Kaniz Fashions Ltd

26th August 2019

Observations

Elevation at grid-1 From ETABS

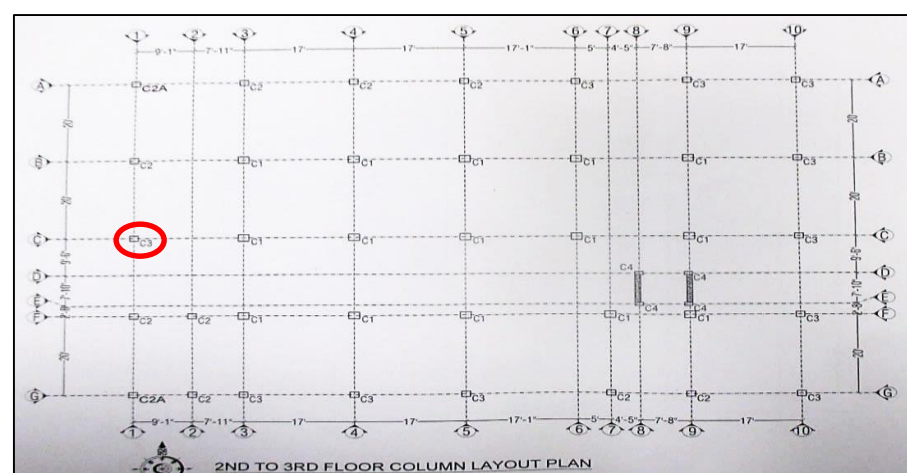
Mismatch found between as built drawing & FEA model

2nd for 6th floor column Layout

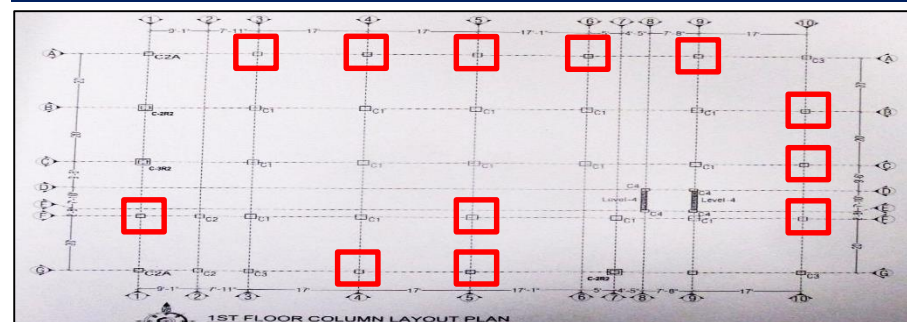
In column layout plan, column ID is missing in several location of different floors.

At grid 1-C, C2 column has been assigned at 2nd & 3rd Floor and C3A column has been assigned at 4th to 6th floor in FEA model. But in as-built drawing only C3 column has been shown from 2nd to 6th floor at that mentioned grid. Also there is no column as C3A in column schedule.

Beam Layout plan in as-built drawing

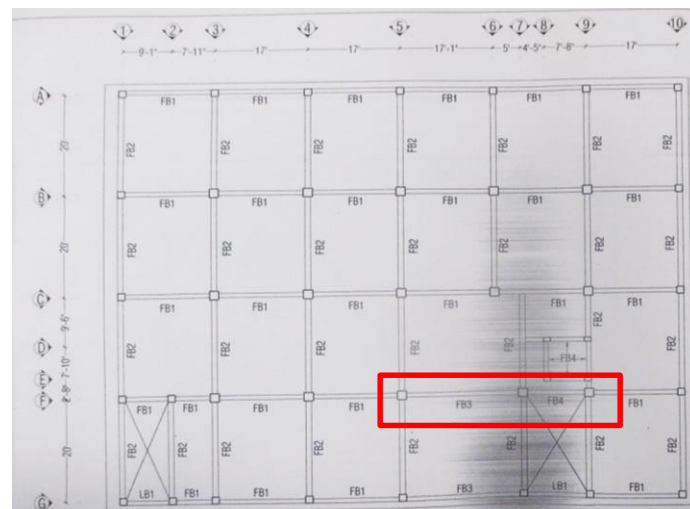
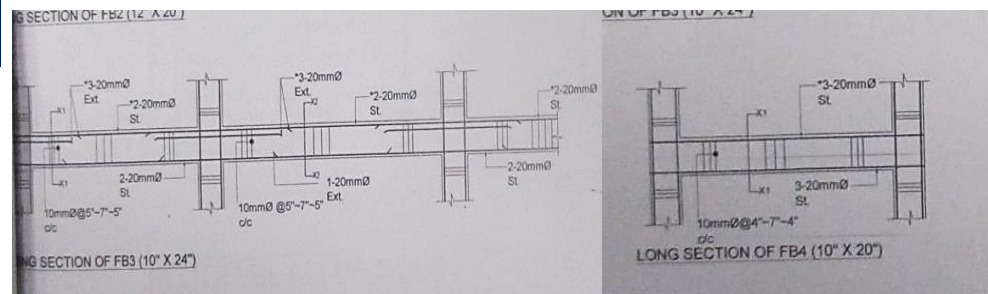
At grid (7-9/F) from 1st floor to stair RB-12X28 has been assigned in FEA model. But in as built drawing FB3- 10X24 beam has been shown. Similarly RB10X28 beam has been assigned in FEA model at grid (5-7/F) instead of FB4 10X20

Assignment of wind loading in FEA model

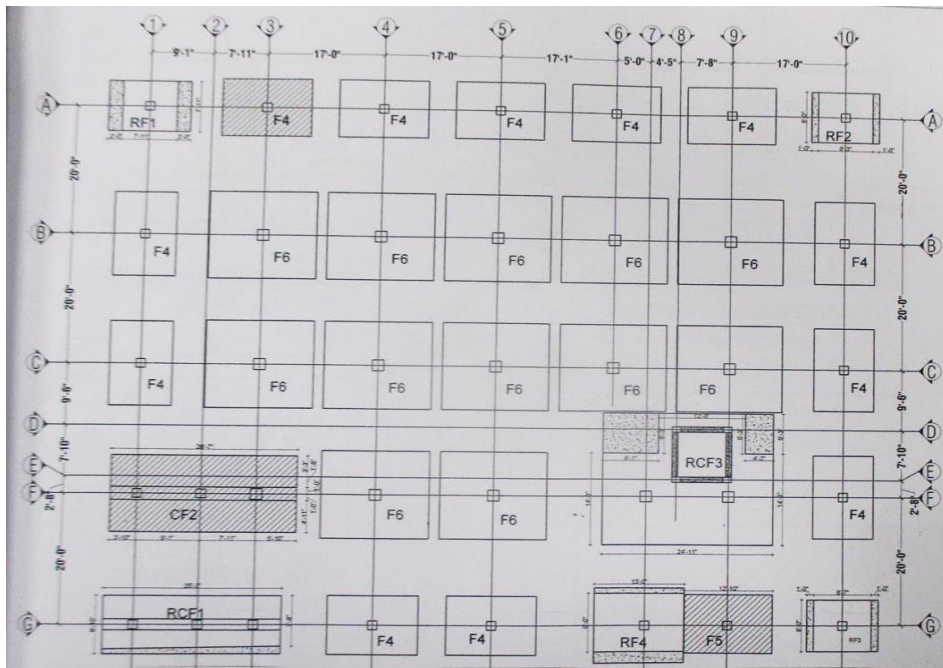
Windward coefficient & leeward coefficient have been assigned as 0.8 & 0.5 respectively. No calculation has been provided in report for the C_{pe} . Factory engineer is required to calculate the required C_{pe} value and assign properly in required directions.
